Q02815

2022	NAME	SIGN	DATE	TITLE: ALUMINIUM EXTRUSION SQUARE INNER TUBE		
DGN	BRIJESH		17.12.22			
DRN	DEEPAK		17.12.22	MATL. AL- 6061(T6)	TYPE: BOUGHT OUT COMPONENT	
CHD	AMIT		17.12.22		DRG NO. TRIP022-01	SCALE 1 : 1
APPR	ANANT		17.12.22		REF. NO. TRIP022	
 ALL DIMENSIONS ARE IN mm				<i>Unspecified tolerance as per IS 2102:1980 (Medium grade)</i>		REV. NO 01

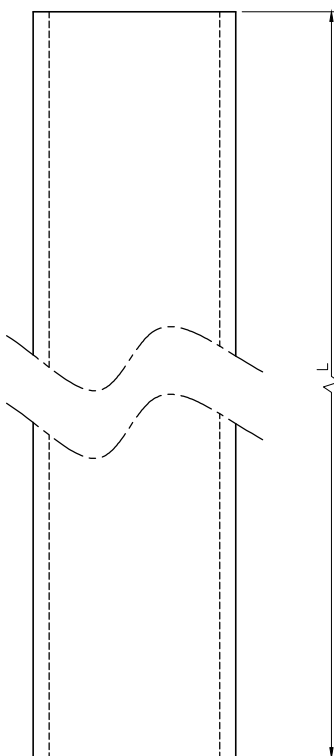
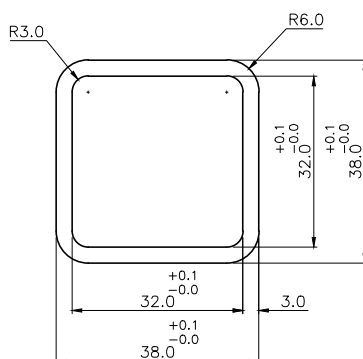
REV. NO.	REVISION DESCRIPTION	REV. DATE
01	CHANGED FROM DIM. 37.5mm(± 0.45) TO 38.0mm($+0.1/-0.0$), 23.5mm(± 0.38) TO 32.0mm($+0.1/-0.0$) AND THICKNESS 7.0mm TO 3.0mm.	17.12.22
